**RE: REQUEST FOR ADDITIONAL INFORMATION - DA/414/2020/A  
PROPERTY AT 172, 174, 176, 178, 180 ANZAC PARADE & 116R TODMAN AVENUE, KENSINGTON**

I refer to the Request for Additional Information (RFI) and Randwick Design Excellence Advisory Panel (DEAP) Endorsed Recommendations provided by Council in relation to the S4.56 Application No. DA/414/2020/A for modifications to the approved student accommodation development.

**Figure 1. Lobby Sections**

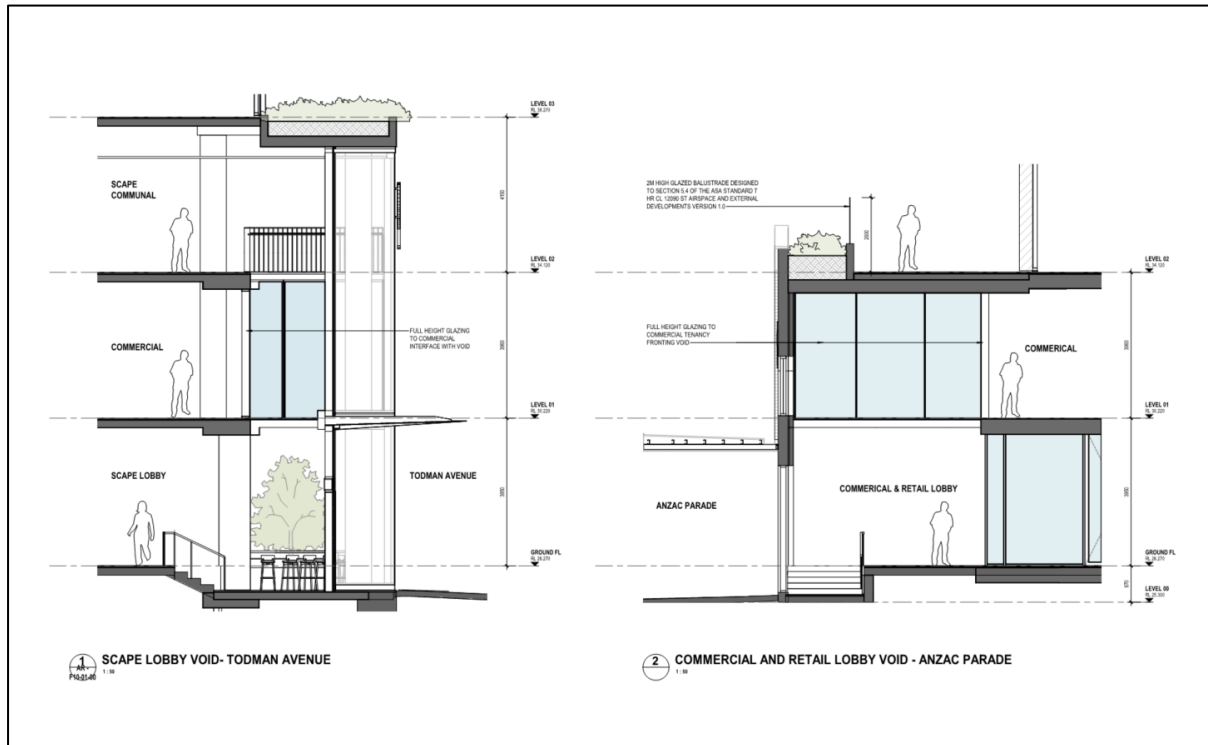
*Clarification is sought on the positioning of the three proposed commercial (Level 1) void areas, whilst it is noted that the void on the Anzac Parade frontage will interface with commercial lobby. It appears that the other two voids will align with the student accommodation lobby and waste servicing areas on the ground floor. Council also notes that the proposed student accommodation void will also connect with the communal level above and this interface would result in potential acoustic conflicts for each of these uses.*

*It is requested that the rationale for the alignment of each of these void areas is clarified by the design team and that Section BB is amended to confirm whether the commercial floor will be isolated from the student accommodation uses.*

The void to the southern part of the building above the Scape residential lobby provides full height glazing surrounding the void at Level 1. The full height glazing prevents any potential acoustic conflicts between the lobby and commercial uses. The architectural plans have been amended to provide notes and clarifications to the void spaces. The plans note full height glazing to the commercial tenancy fronting the void and detailed lobby sections are provided to demonstrate the arrangement more clearly. The Lobby Section is reproduced in **Figure 1** below:

Figure 2. Approved planted beds showed on Levels 03 to 09.

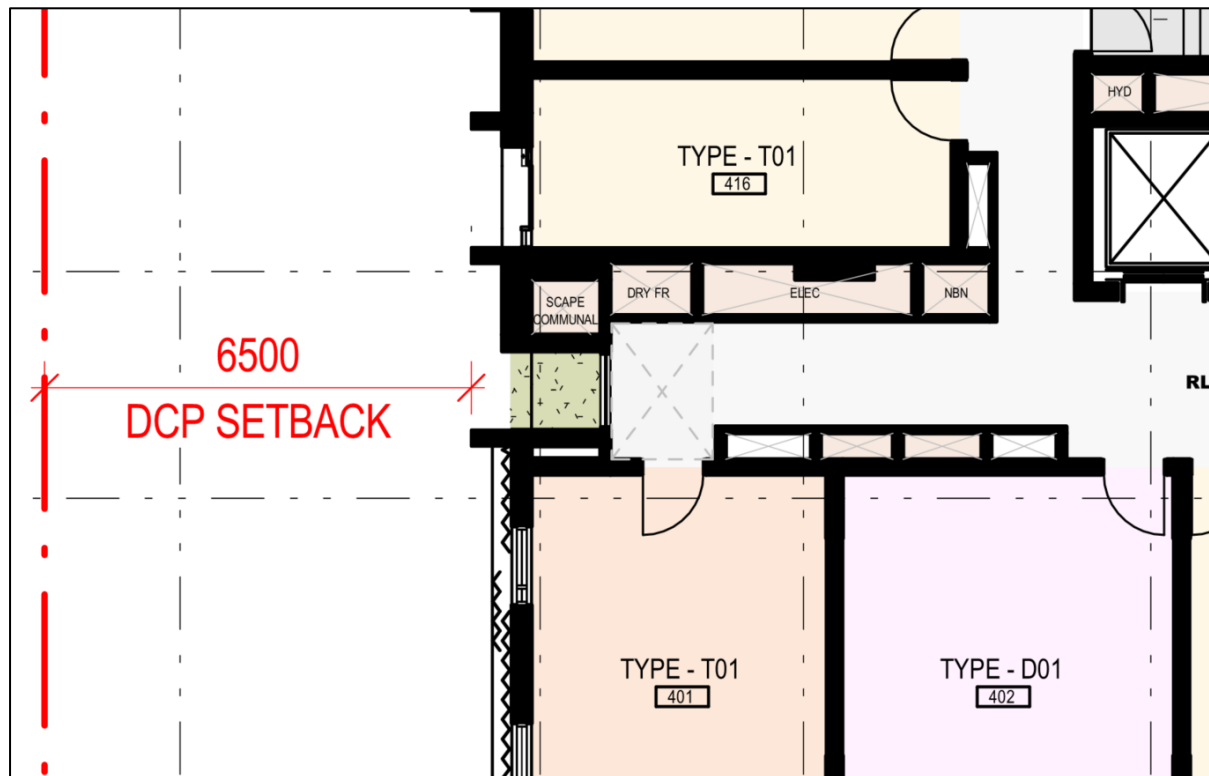
The deletion of the vertical landscape slot from the tower should be balanced with compensating green element infrastructure elsewhere in the scheme.

It is understood that the above comment from the DEAP is referring to the 1m x 1m planter bed as seen on the floor plan of Levels 03 to 09 (see **Figure 2**). The planters were removed from the scheme as a result of detailed design development for the following reasons:

- The proposed planter beds as shown on the West Elevation of the BVN scheme constitutes a waterproofing issue; and
- The proposed planter beds are located on the external of the building behind a fixed closed window. The maintenance of the planter beds would be extremely difficult and would require additional service access.
